UNITED STATES  
NUCLEAR REGULATORY COMMISSION  
WASHINGTON, D. C. 20555

MEMORANDUM FOR: Vincent S. Noonan, Director  
Comanche Peak Project

SUBJECT: FEEDBACK INTERVIEW OF WITNESS A-4

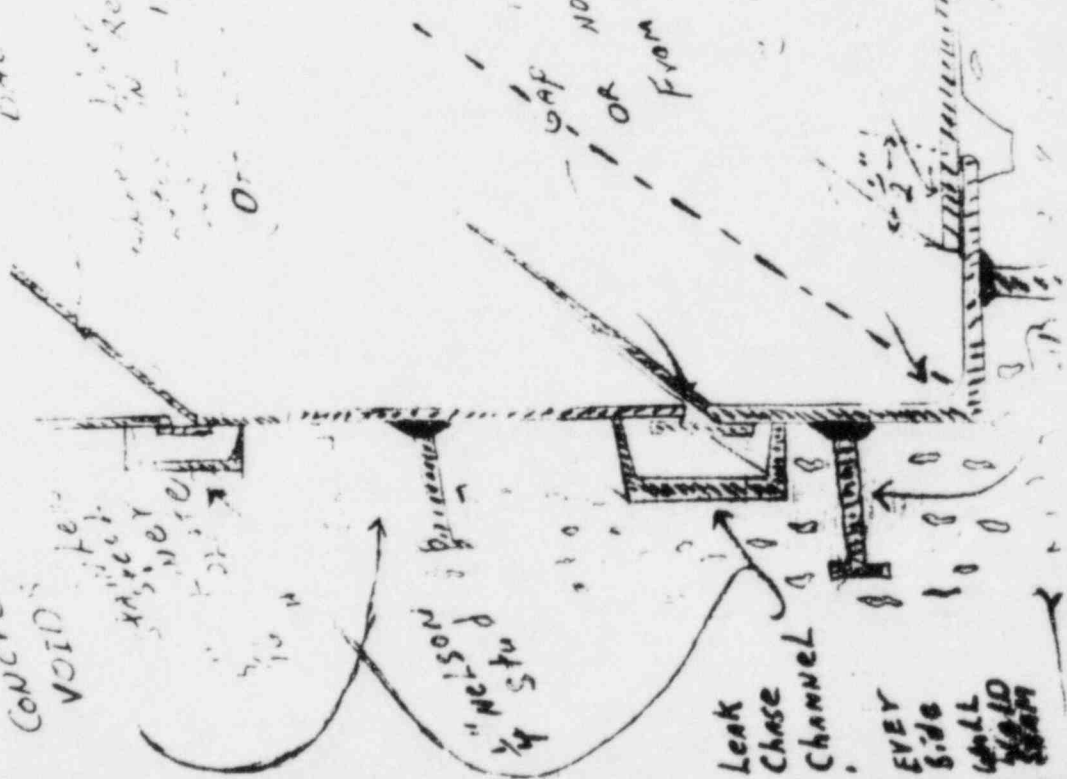
Packing strip improperly located

Concrete H<sub>2</sub>O  
VOID

Leak  
Chase  
Channel

FLOOR TO 10" IN CASE  
IS OF THIN 1/2  
NO LESS THAN 1/2  
IT DID NOT EVEN REACH (1/2)

THAT IS BELOW WATER LEVEL HAS A LEAK CHASE CHANNEL EXCEPT FOR THE BOTTOM SEAMS IN BOTH CONTAINMENT

WHERE THERE WAS NO BACKING STRIP IT WAS BUT NO BACKING STRIP

IN THE FUEL BUILDING WAS IMPROPERLY WELDED

3" x 3/4" FLOOR PLATE TO OVER LAP ANGLE IS SUPPOSE TO BE 1/2" IN SOME AREAS NO LESS THAN 1/2" REACH HAD TO BE IT DID NOT EVEN BRIDGED

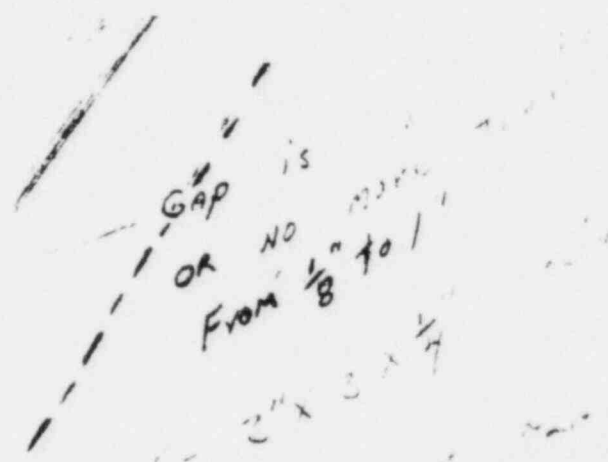
WHERE ANYONE  
SOME PLACES HAS NO BACKING STRIP  
IT WAS BUT WELDED USING WIRE FOR  
BACKING STRIP

IN SOME AREAS NELSON  
IMPROPERLY WELDED

IMPROPERLY MATERIAL  
STAINLESS STEEL

JUST BOAT REPAIR  
STAINLESS STEEL  
ENTER NO. 1 AND FUEL BACKING  
HAS SAFETY RELATED PROBLEMS

BACKING STRIP IMPROPERLY INCLUDED  
AND FLOORS AND FITTED

STAINLESS LINER WITH NO. 1 NO. 2  
PHATES IN REACTOR NO. 2 NO. 2  
AND FUEL BUILDING IMPROPERLY INSTALLED  
(OFF L.C.T. ...)
